Proposal: Side extension to converted outbuilding (resubmission following BN/24/17/PL). This application affects the character & appearance of the Church Lane, Barnham Conservation Area.
Site: 1 Little Barton, Church Lane, Barnham, PO22 0BW.
BN/18/18/HH

ARUN DISTRICT COUNCIL BN/18/18/HH

Due to surface water inundation issues in the Lidsey Catchment "The applicant is advised to adopt, where appropriate, the measures in the table "Practical measures to reduce the potential impacts of development".

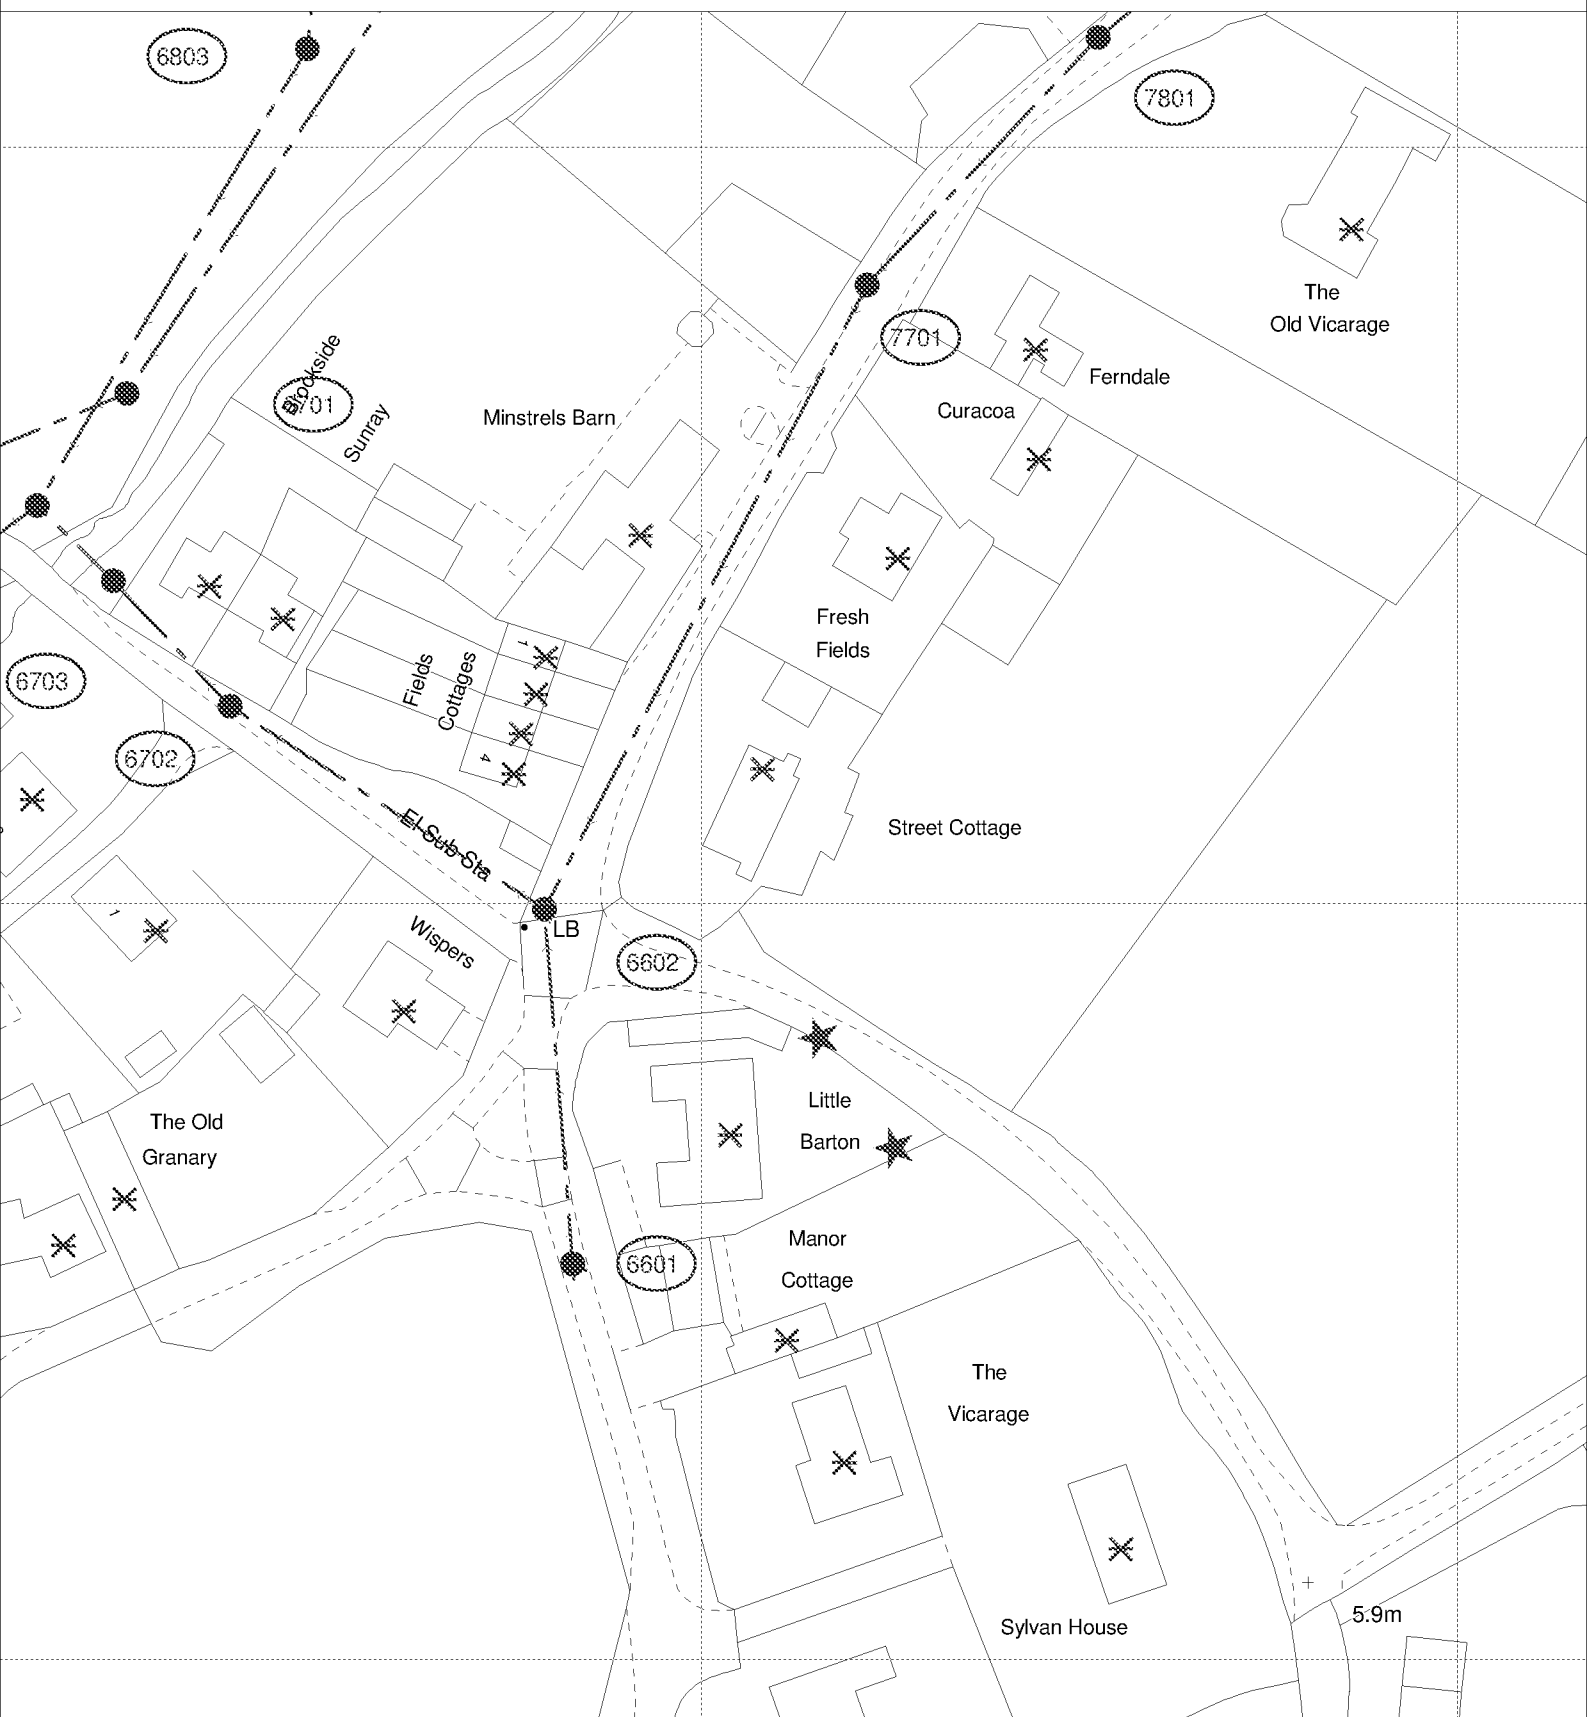
Developer should look to protect the public sewerage system from inundation and infiltration, which contribute to flooding in unfavourable conditions.
